Thames Crossing Action Group represents thousands of people who are strongly opposed to the proposed Lower Thames Crossing. We object to the proposed Lower Thames Crossing for many different reasons and do not consider the project to be in any way fit for purpose.

Our response to the London Resort Consultation particularly focused on the aspect of the relationship between the proposed London Resort (LR) and the proposed Lower Thames Crossing. This is because we are aware of some very serious issues that we believe have not been noted or addressed in materials that we have viewed, and we have serious concerns over this.

Inadequacies of London Resort Consultation

LR PEIR Fig 9.2 Highway Traffic Model Extent -

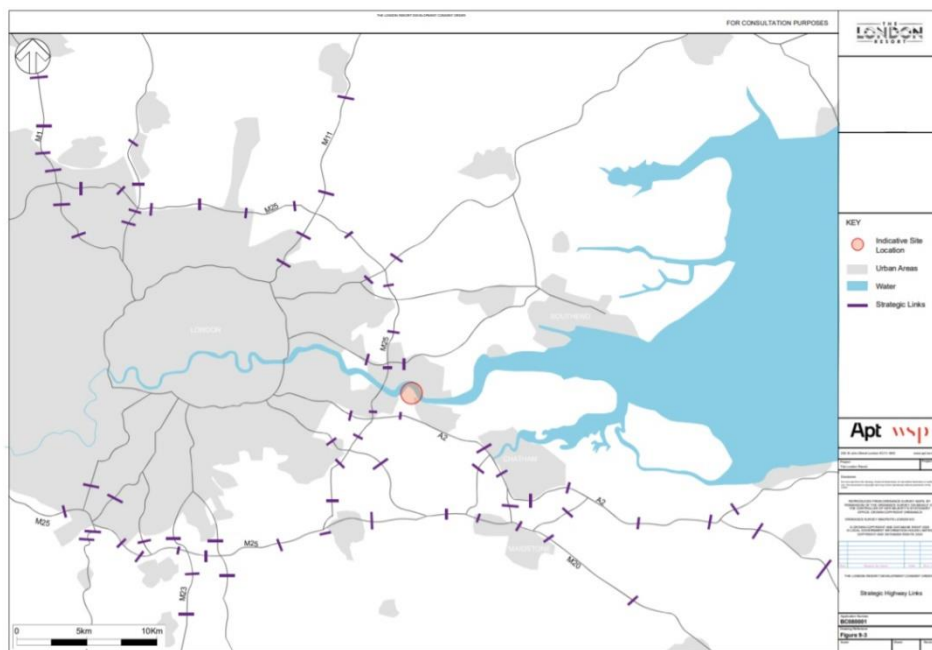
This document is incorrect as London Resort have the A13 near Stanford-le-Hope labelled as the A1089 (circled in pink on the image above). Considering that the A1089 is the route they are proposing traffic access the proposed parking facility in Tilbury this is very misleading and poor performance from LR to not even be able to identify and label it correctly on a map.

In addition the actual A1089 is not even marked in green on the map, which is supposed to show model links. Again considering traffic will have to use the A1089 to access the parking facility in Tilbury this is unacceptable and very concerning that they have failed to include it.

There are also routes marked in green that do not make sense as to why they should be included. Some of the green highlighted routes include very small/short isolated sections, which again make no sense. (We have circled the most random ones in red on the image above.)

We particularly enquired via email about the inclusion of Baker St, High Rd, Rectory Rd in Orsett (circled in blue in image above), and were told, “*These links have been included due*

to the potential changes in traffic flows along the A13 which could impact upon local communities within the vicinity.”

Since none of these three roads are directly accessible from the A13 this doesn't provide a clear and informative reply. However, it would suggest that if this is the case that other junctions and roads should also be highlighted, simply by fact that they would need to be used to access these roads alone.

The map used in this document doesn't even clearly show the fact that these roads are not directly connected to the A13.

We can in no way understand why LR have highlighted the 'junction' for want of a better word that we have circled in orange. Again this is not a route that is directly accessible from the A13 as their map gives the impression of. It is also a very strange assumption to come to that this route would be impacted, and there is no explanation as to why.

LR are including the proposed Lower Thames Crossing in this map, yet LR are not highlighting the Stanford-le-Hope junction on the A13. Any traffic attempting to use the LTC (or indeed the Orsett Cock junction of the A13, including the A128 traffic) to access the A1089(south) would all have to detour to the Stanford junction to go up and around the traffic lighted roundabout and head back westbound on the A13 to reach the new proposed joint LTC/A1089(south) junction to access the A1089 southbound to the proposed London Resort Parking facility in Tilbury.

When we raised this point via email with LR we were told, “*We agree that this link may be used to reach the Tilbury parking facility. We will include this link, along with many others, within the traffic modelling as we progress.*”

LR PEIR Fig 9.3 Strategic Highway Links -

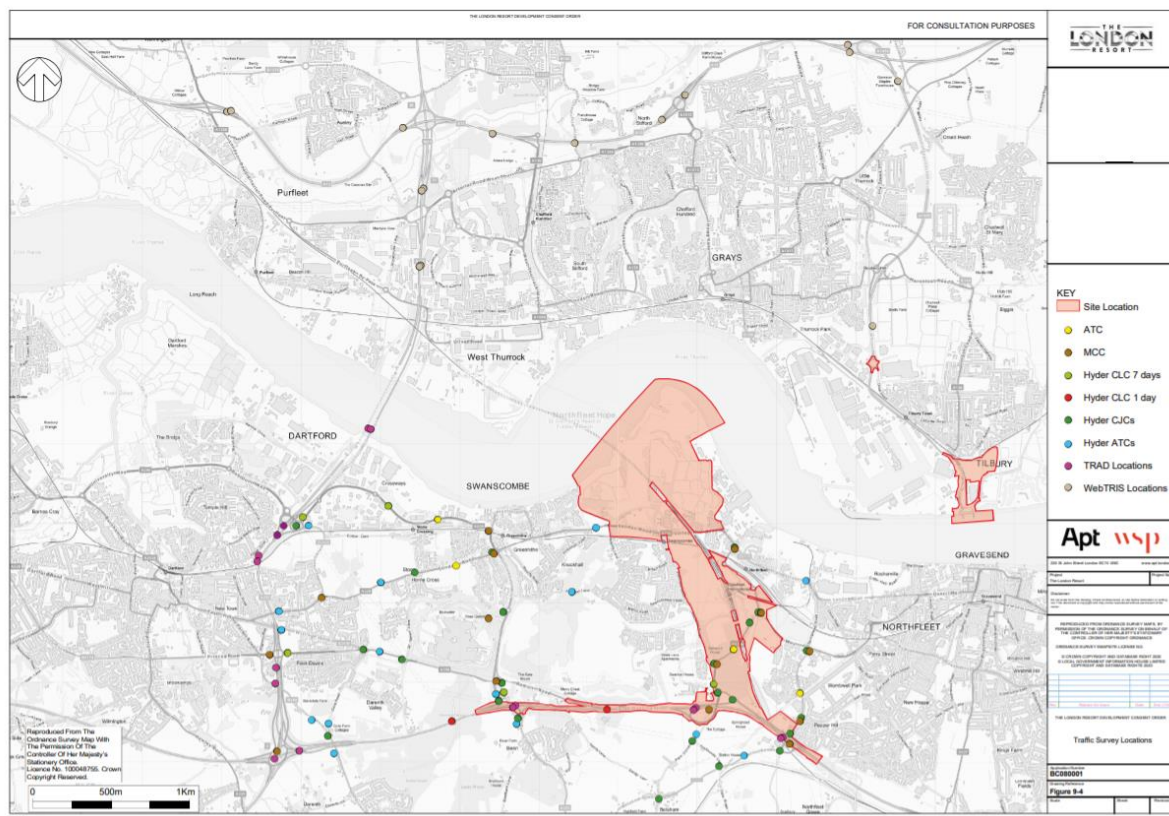
The map above is supposed to show strategic links. How can lines marked on a map without any labelling be considered adequate? It is not even clear whether the A1089 is marked on this map or not. Some of the lines intersect routes, but do not show what junction it is, or indeed even the route which it is on, as only a few random roads are actually labelled.

The proposed parking facility to the north of the river in Tilbury is not even marked on the map either.

Clearly this is not the case as figure 9.3 is an inadequate poorly labelled image which does not provide clear and informative detail that is legally required for an adequate consultation.

LR PEIR Fig 9.6 Strategic Highway Network –

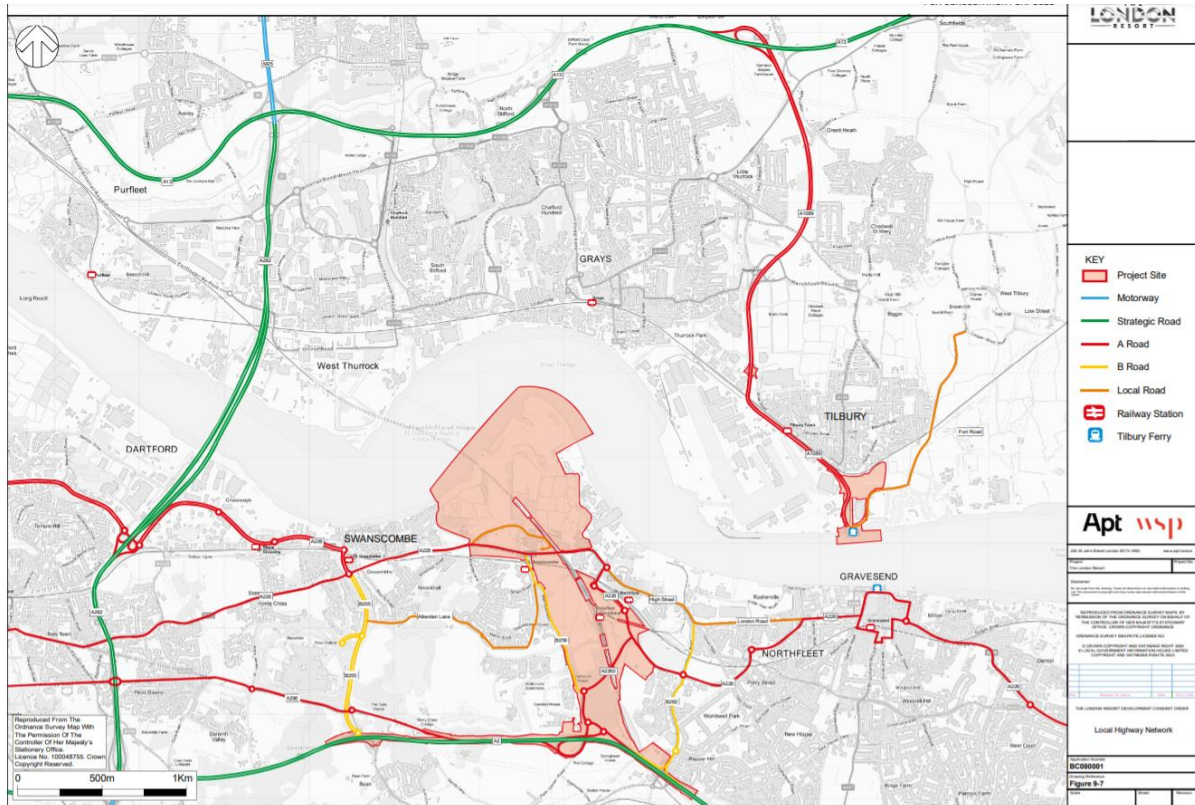
The figure above is supposed to show the Strategic Road Network. However LR have glaringly omitted to include the A13 up to the A1089, and the A1089 itself, both of which are part of the Strategic Road Network. Yet another inadequacy of the consultation materials, and proof of lack of clear and informative materials.
